Date: February 13, 2023

Project: D99 Capital Summer 2023

Subject: ADDENDUM #1

Project No: 220242

C1.01

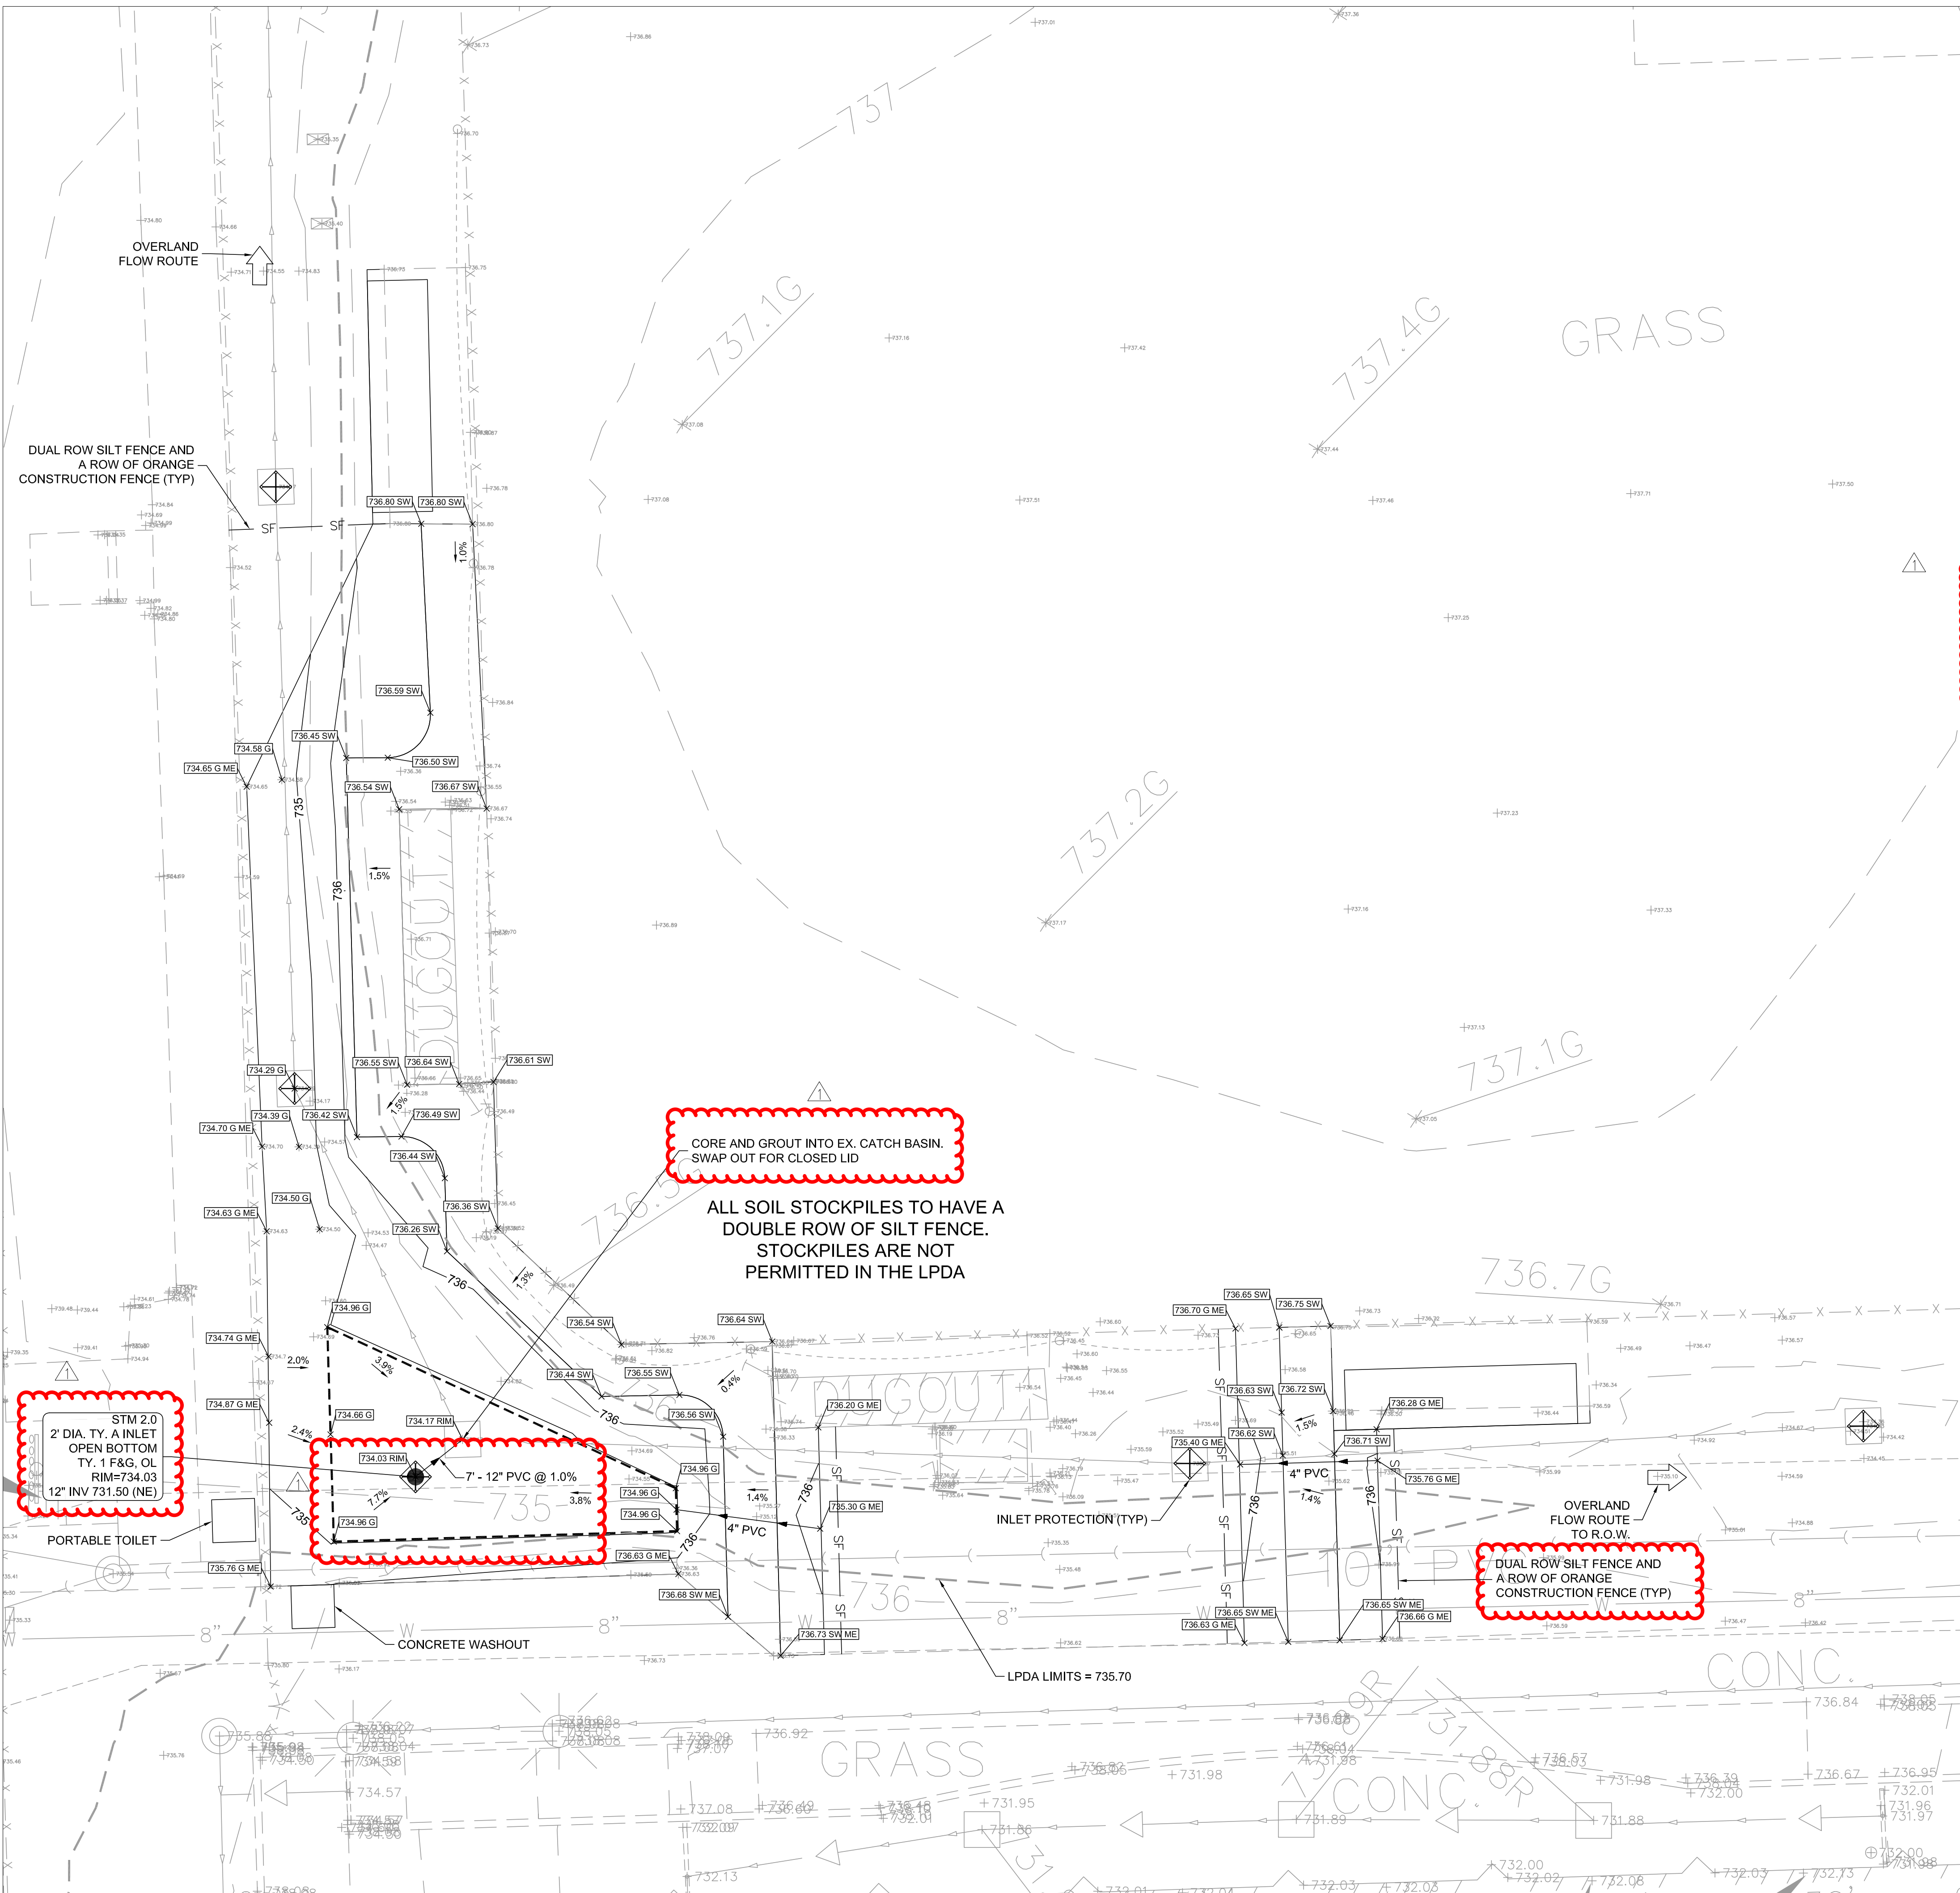
1. **SHEET C1.01** (FULL SIZE SHEET REISSUED)
 - Existing storm structure is now to remain.
2. **SHEET C3.00** (FULL SIZE SHEET REISSUED)
 - Notes 11 through 15 have been added.
 - STM 2.0 has been revised
 - Erosion control notes have been added.
 - Storm sewer has been added.
3. **SHEET C4.00** (FULL SIZE SHEET REISSUED)
 - Detail 7 has been revised.
4. **SHEET C4.01** (FULL SIZE SHEET REISSUED)
 - Detail 2 has been revised
